## CIVIL CONSULTANTS

Re: Beam Sizing  
41 Stevens Avenue, Portland, ME

Per your request, an analysis has been performed to determine the support beam needed to allow the removal of an existing wall at the above referenced property, per the requirements of the 2009 International Residential Code.

Enclosed: Reference floor plans, beam in question is "BEAM SIZED BY OTHERS" indicated on sheet 2 of 2

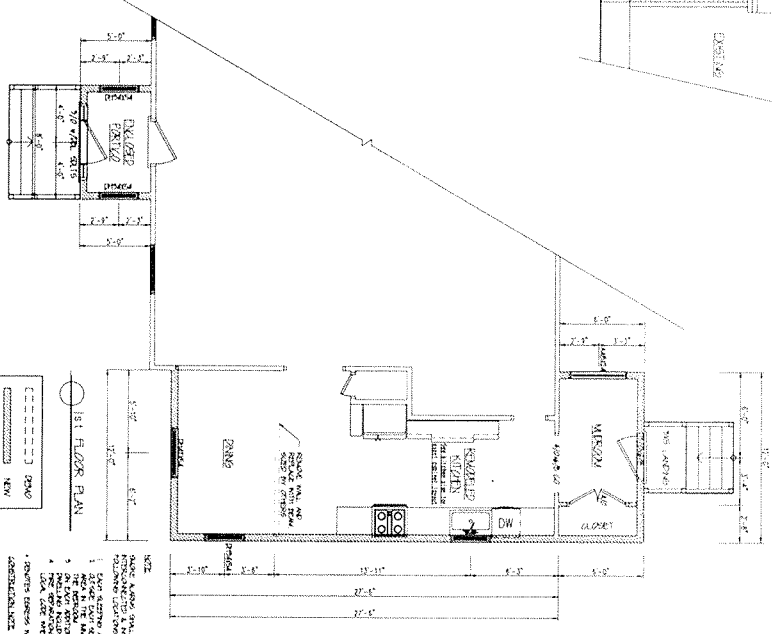
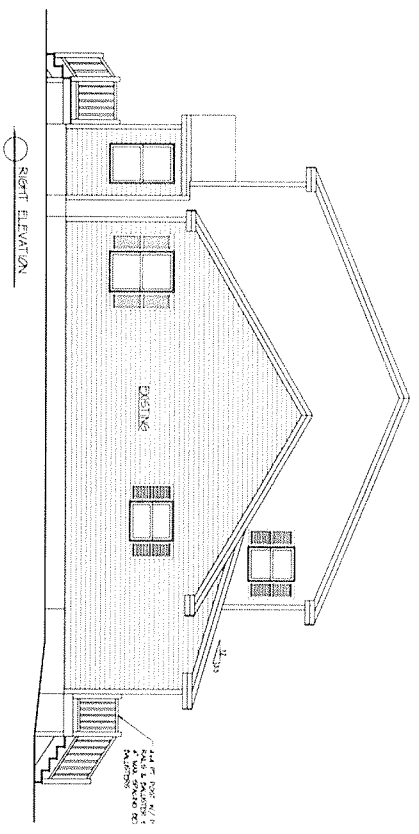
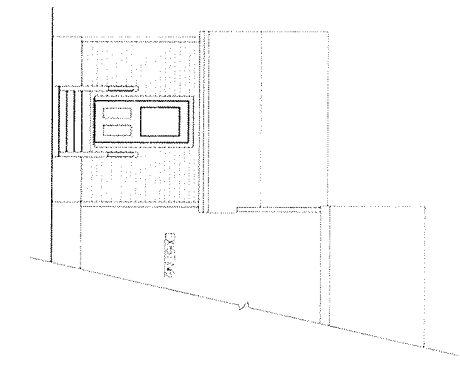
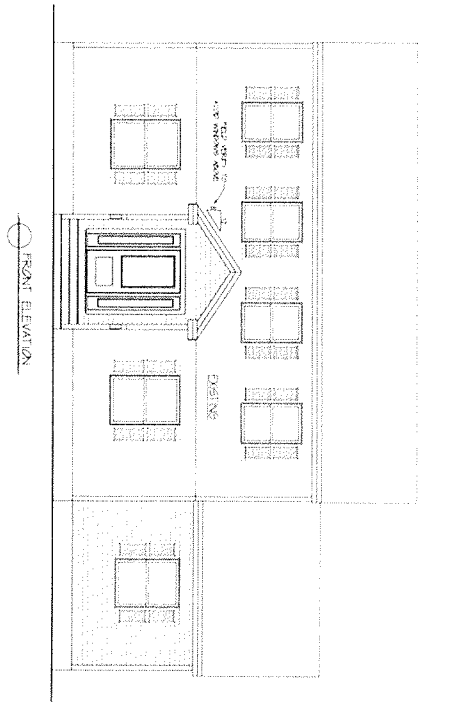
It is proposed that a 12'-0" section existing wall of the one story portion of the house be removed and replaced with an engineered lumber beam to allow for an open concept kitchen/dining area. It is assumed that the supported area will be used as attic storage (20 psf) on existing ceiling joists. These joists are assumed to be adequate to tie the bearing ends of the roof rafters and maintain the stability of the structure as it exists. Capacities of the joists have not been evaluated as part of this evaluation as no change in loading or support is proposed. If the framing varies in any way from a simple roof rafter and ceiling joist system, beam sizing indicated in the following paragraphs shall be re-evaluated along with any new framing that may be required to support the proposed modifications.

It is assumed that all roof loading will be supported by the exterior walls and no loads will be directed to the beam in question.

In order to support the second floor live loads and associated dead loads, a header consisting of two 1 3/4"x9 1/2" Versa-Lam 2.0 3100 engineered lumber members is required. Each member of the built-up beam is assumed to be continuous. The header is to be installed below the existing ceiling joists so as to not require cutting into the existing framing. The manufacturer's requirements are to be followed with regard to connecting the separate beam plies. Simpson H2.5A ties are to be installed connecting the header to the joists at a maximum spacing of 24" on center.

Bearing members below the beam shall consist of SPF studs providing full bearing to the supporting basement framing. It is assumed that these studs will be blocked solid to the foundation below. No evaluation of the floor framing or foundation has been performed as part of this review. If required, posts and foundation elements shall be sized to safely support 3,000 lbs at both beam bearing locations.

Existing framing shall be adequately supported during construction with temporary bearing walls on either side of the proposed opening until the new header is installed and all connectors have been installed.
